Access Compliance Report

Public Rights-of-Way

(Curb Ramps)

Intersection ID: 45221	Main Street: HARCOTBE_DR	Cross Street: LISSADELL_CR	Location:	NW
ADA ID: 93083BE21DE0	Ramp Type: Perp	Initial Pass/Fail: Fail	Overall Compliance: No	Severity Score: 25
Codes/Mitigation Info/Possible Solution		Field Measurements/Component Compliance

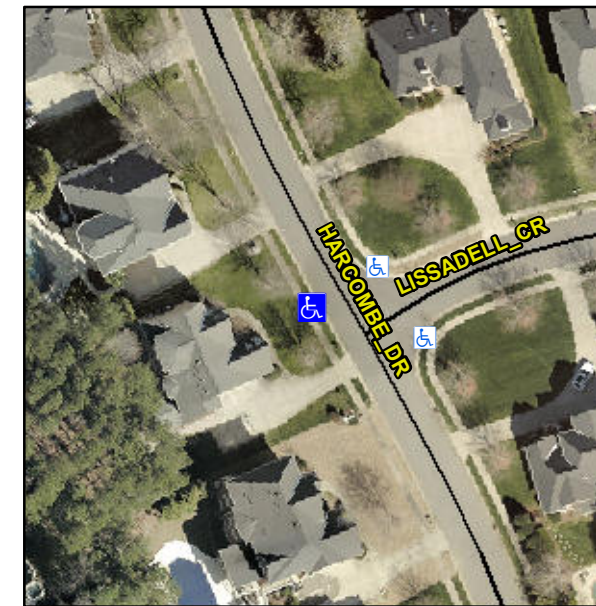
Not Found, R304.2.2, R304.5.3

Compliance	Description	Data	Compliance	Description	Data
N/A	Ramp Length (in)	46.5	No	Ramp Slope (%)	8.6
Yes	Ramp Width (in)	60.5	No	Ramp XSlope (%)	6.5
N/A	Flare Type LT	N/A	N/A	Flare Type RT	N/A
N/A	Flare Slope LT (%)	N/A	N/A	Flare Slope RT (%)	N/A
N/A	Flare Traversable LT?	N/A	N/A	Flare Traversable RT?	N/A
N/A	Landing Length (in)	N/A	N/A	DWS Provided?	N/A
N/A	Landing Width (in)	N/A	N/A	DWS Contrast?	N/A
N/A	Landing Slope (%)	N/A	N/A	DWS Length (in)	N/A
N/A	Landing X Slope (%)	N/A	N/A	DWS Full Width?	N/A
N/A	Landing Curb? (Y/N)	N/A	N/A	DWS Offset (in)	N/A
N/A	Shared Landing?	N/A			
N/A	Gutter Ponding?	N/A	N/A	Gutter Slope (%)	N/A
N/A	Gutter Lip Ht (in)	N/A	N/A	Gutter X Slope (%)	N/A
N/A	Painted X Walk1?	No	N/A	Painted X Walk2?	N/A
	X Walk 1 Direction	To E		X Walk 2 Direction	N/A
N/A	X Walk 1 Width (in)	N/A	N/A	X Walk 2 Width (in)	N/A
	X Walk 1 Slope (%)	1.5		X Walk 2 Slope (%)	N/A
	X Walk 1 X Slope (%)	7.6		X Walk 2 X Slope (%)	N/A

Remove & Replace Entire Ramp.
